To: T10 Committee (SCSI)

From: George Penokie (IBM/Tivoli)

Subject: SAS 1.1 - Transport layer retry and argument passing fixes

Figure 149 — ST\_I (transport layer for SSP initiator ports) state machines

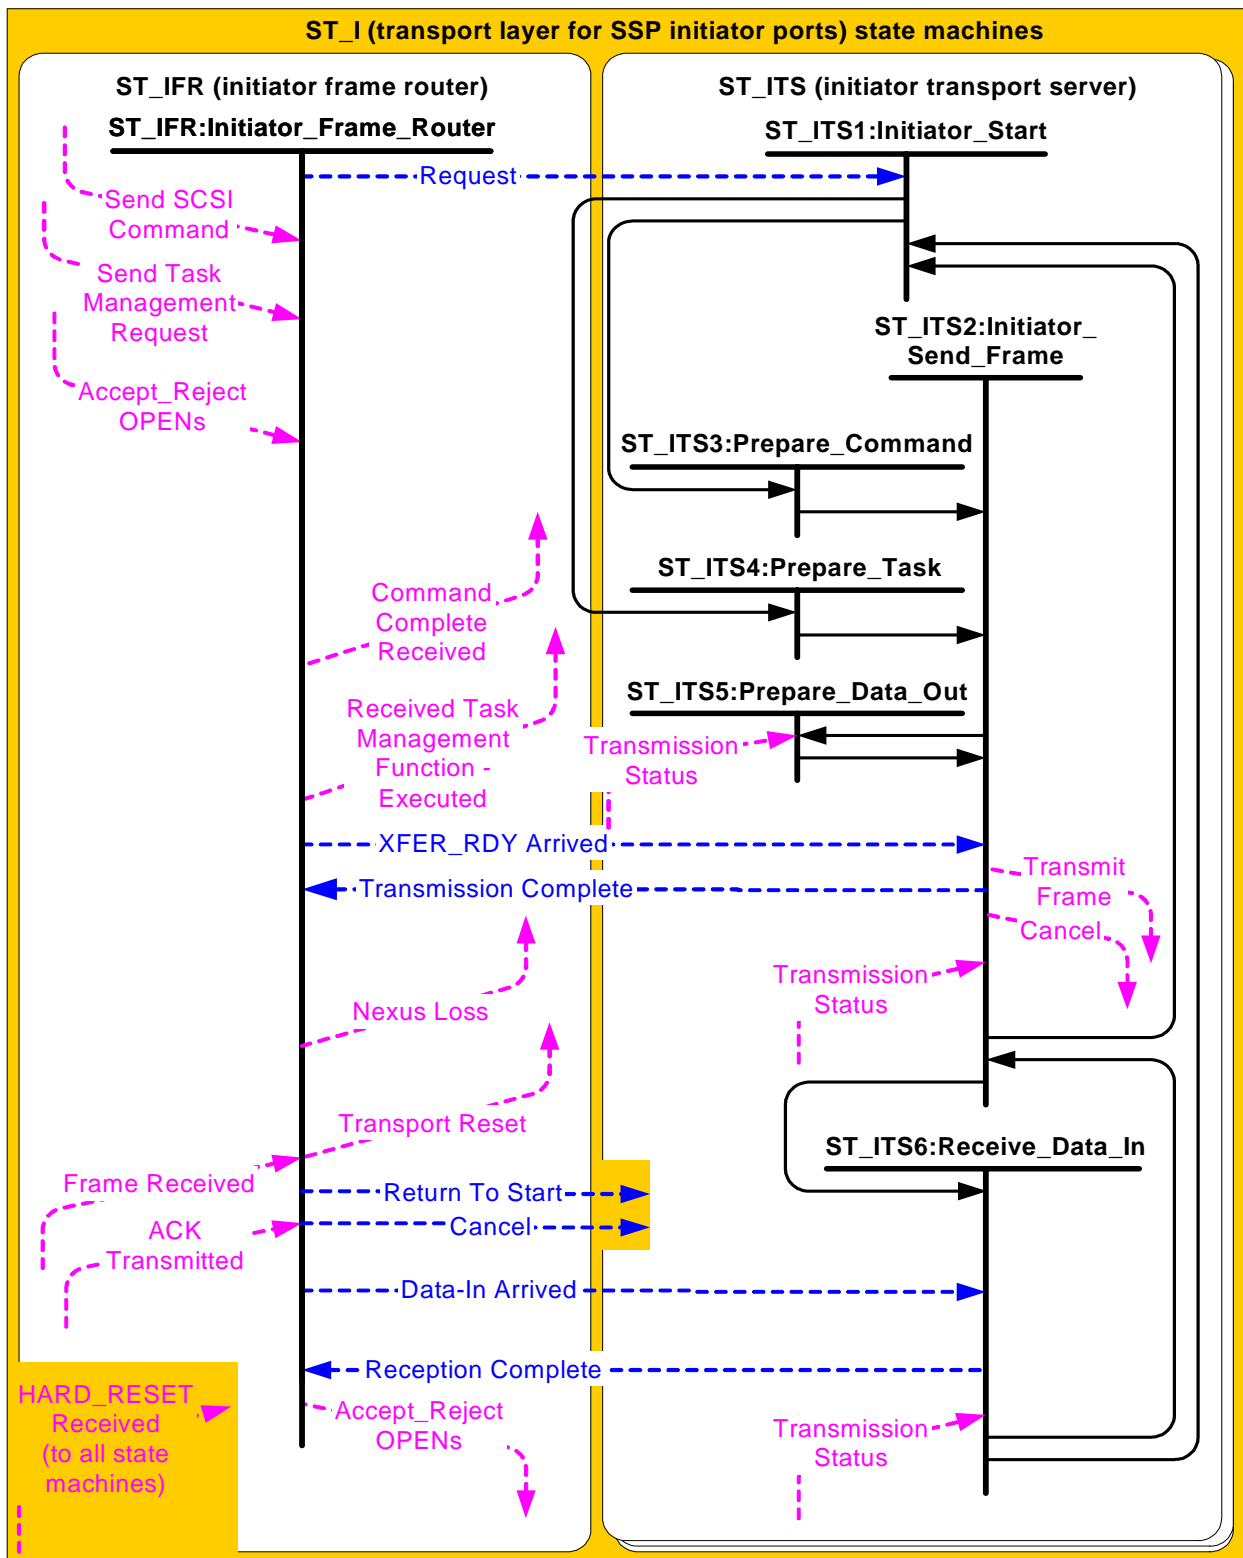
Editor's Note 14: Added Data-In Arrived message into ST\_ITS7 and Transmission Status confirmation into ST\_ITS5 to allow for non-interlocked DATA frame transfers. Changed Cancel message to go to all states. Added a Return To Start message to all states. Deleted ST\_ITS7. Added transition from ST\_ITS1 to ST\_ITS3 and ST\_ITS4. Deleted transition from ST\_ITS2 to ST\_ITS3 and from ST\_ITS2 to ST\_ITS4.

Figure 150 — ST\_T (transport layer for SSP target ports) state machines

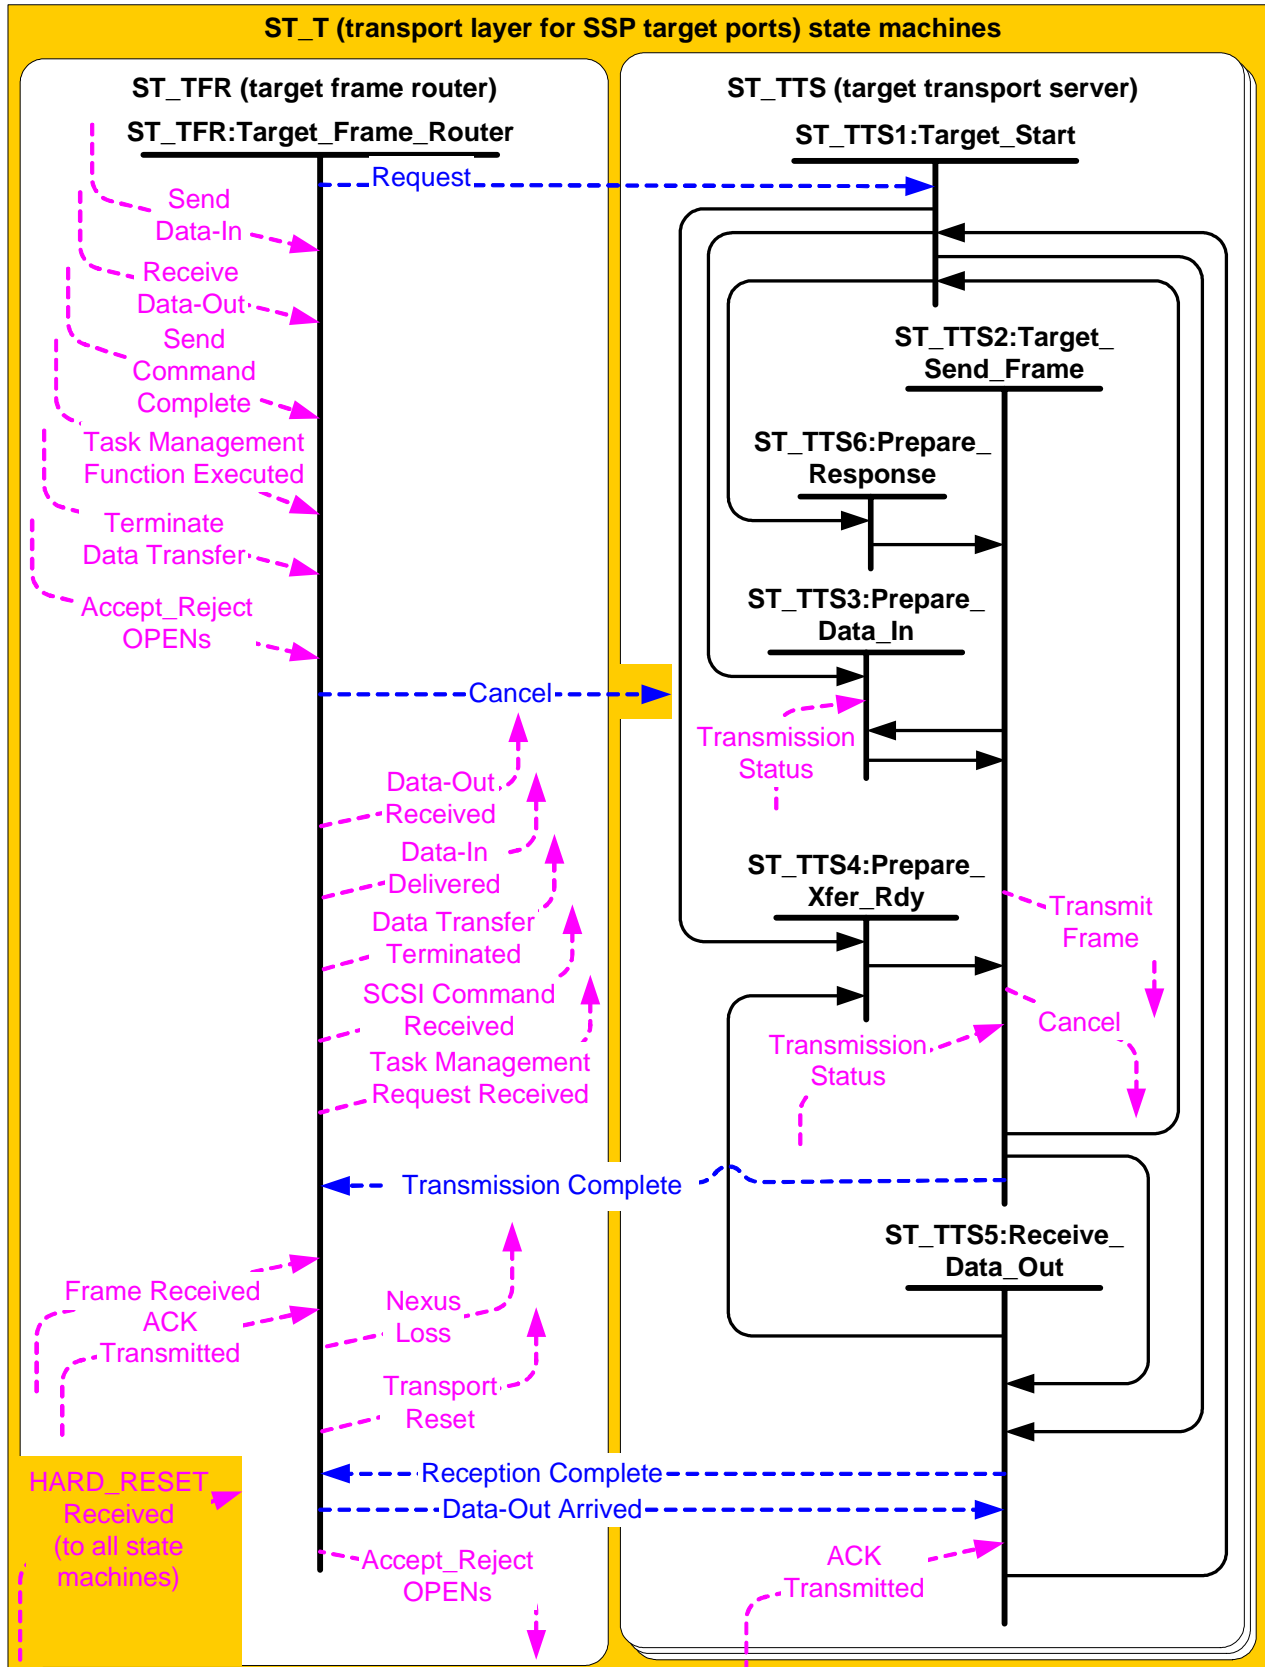
Editor's Note 15: Added Transmission Status confirmation into ST\_TTS3 to allow for non-interlocked DATA frame transfers. Changed Cancel message to go to all states. Added ACK Transmitted to ST\_TTS5. Deleted ST\_TTS1 to ST\_TTS2 transition, ST\_TTS5 to ST\_TTS2 transition, ST\_TTS7 to ST\_TTS2 transition, and ST\_TTS4 to ST\_TTS2 transition. Added ST\_TTS1 to ST\_TTS3 transition, ST\_TTS1 to ST\_TTS4 transition, ST\_TTS1 to ST\_TTS7 transition, and ST\_TTS5 to ST\_TTS4 transition. Change ST\_TTS7 to ST\_TTS6.

Figure 151 — ST\_I (transport layer for SSP initiator ports) state machines

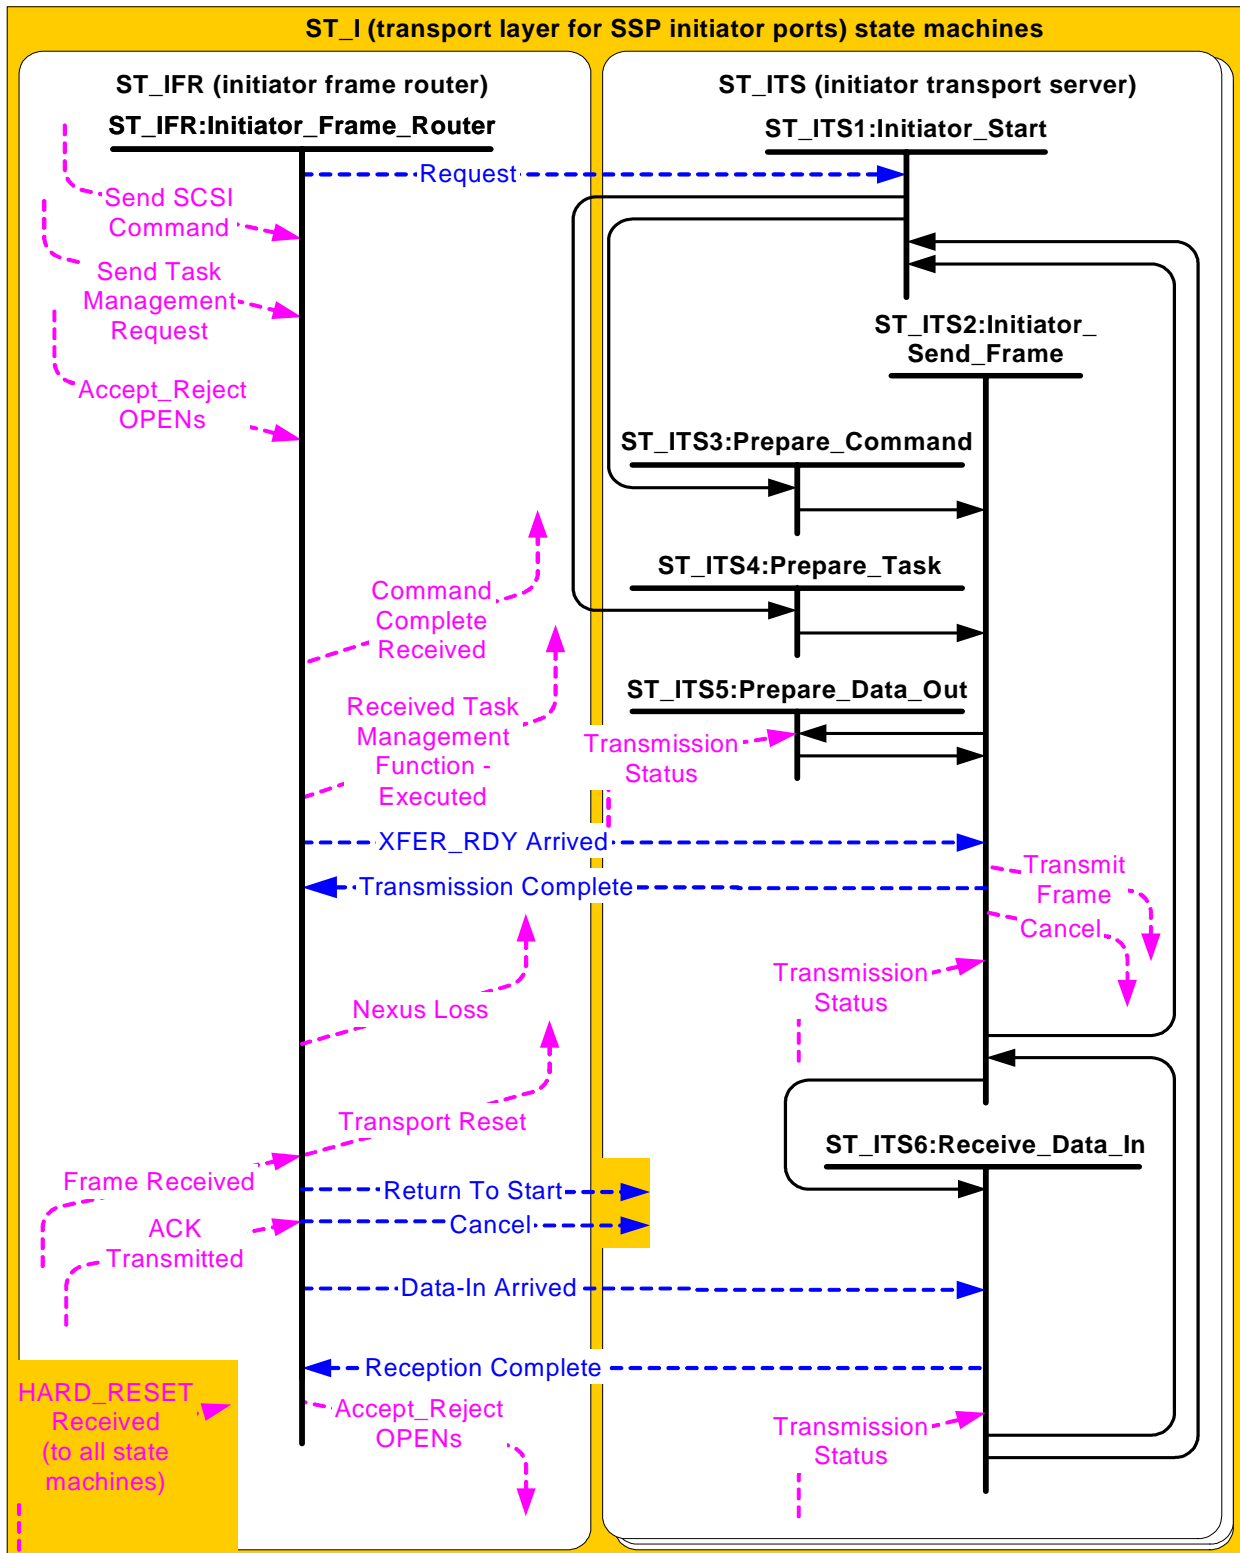
Editor's Note 16: Added Data-In Arrived message into ST\_ITS7 and Transmission Status confirmation into ST\_ITS5 to allow for non-interlocked DATA frame transfers. Changed Cancel

[message to go to all states. Added a Return To Start message to all states. Deleted ST ITS7. Added transition from ST ITS1 to ST ITS3 and ST ITS4. Deleted transition from ST ITS2 to ST ITS3 and from ST ITS2 to ST ITS4.](#)

Figure 152 — ST\_T (transport layer for SSP target ports) state machines

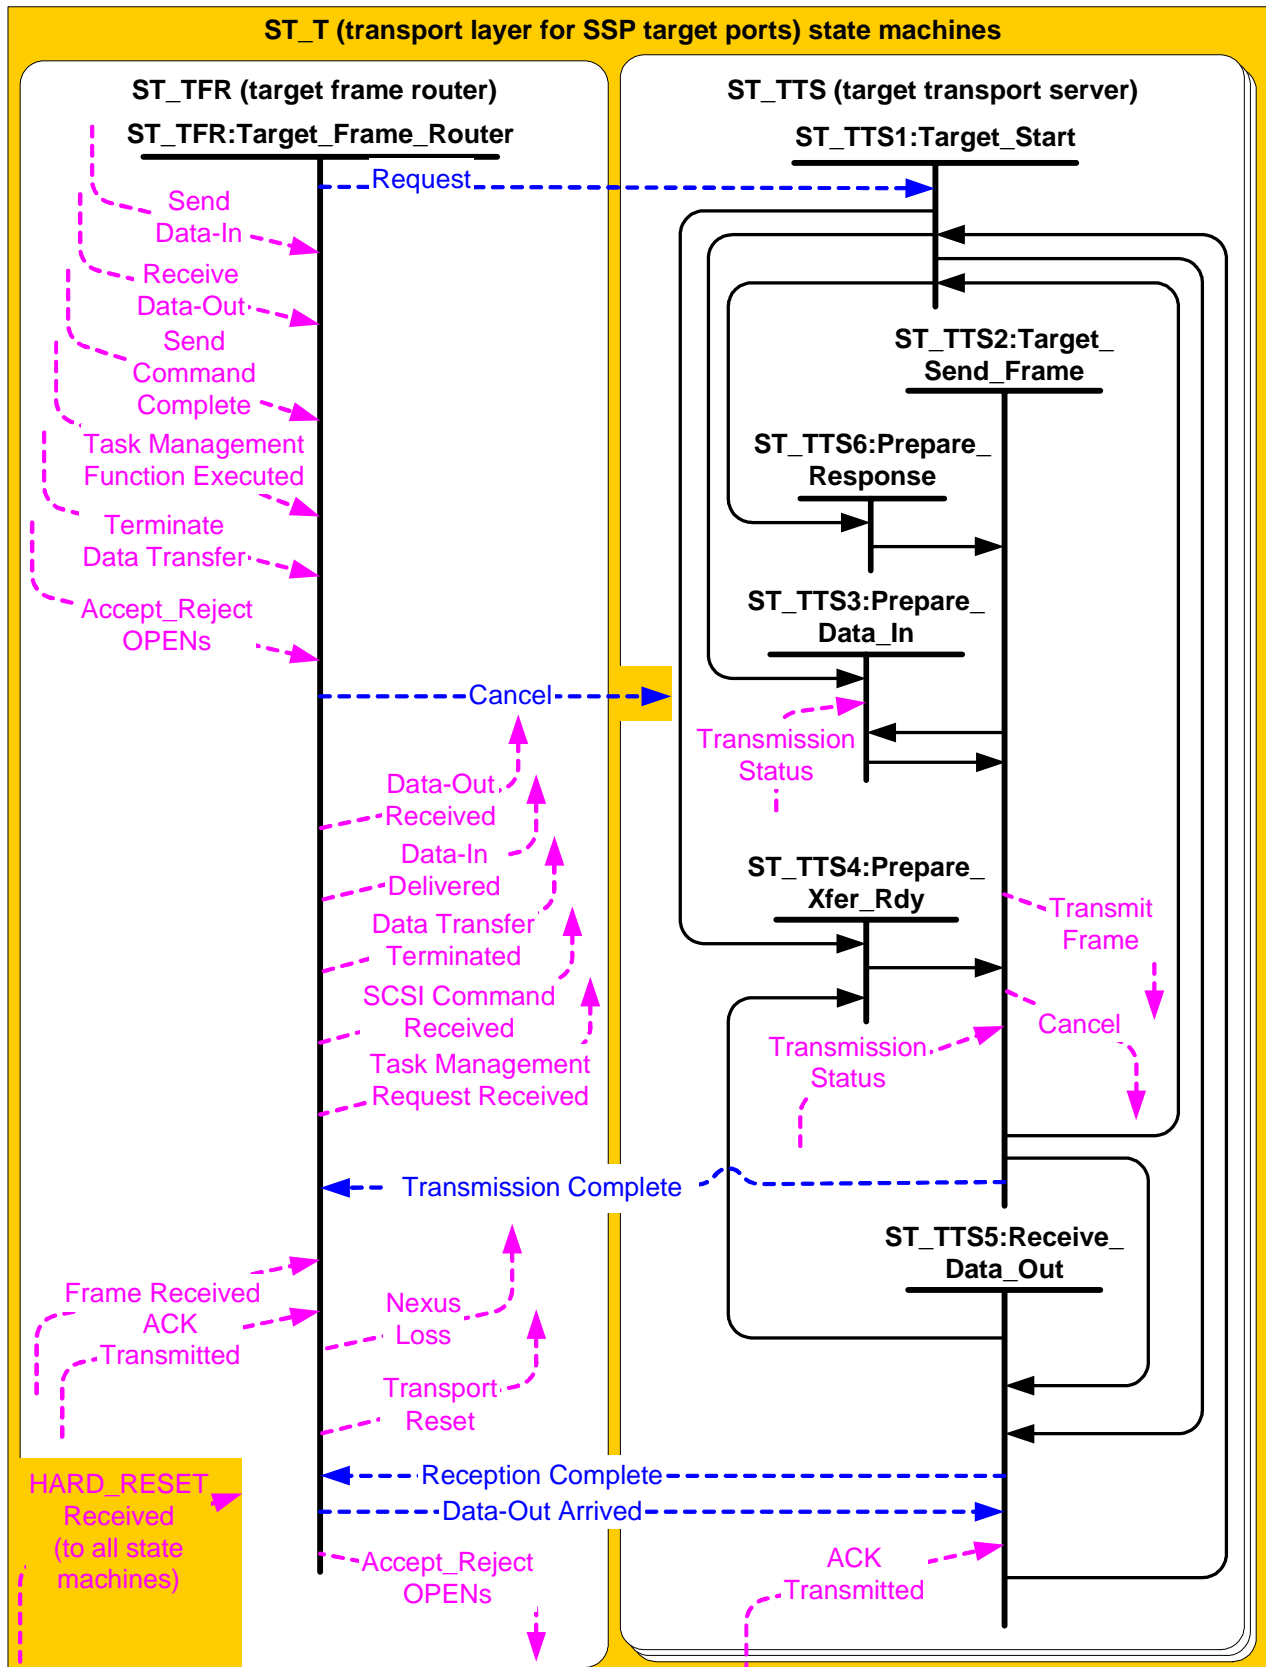
[Editor's Note 17: Added Transmission Status confirmation into ST\\_TTS3 to allow for non-interlocked DATA frame transfers. Changed Cancel message to go to all states. Added ACK Transmitted to ST\\_TTS5. Deleted ST\\_TTS1 to ST\\_TTS2 transition, ST\\_TTS5 to ST\\_TTS2 transition, ST\\_TTS7 to ST\\_TTS2 transition, and ST\\_TTS4 to ST\\_TTS2 transition. Added ST\\_TTS1 to ST\\_TTS3 transition, ST\\_TTS1 to ST\\_TTS4 transition, ST\\_TTS1 to ST\\_TTS7 transition, and ST\\_TTS5 to ST\\_TTS4 transition. Change ST\\_TTS7 to ST\\_TTS6.](#)
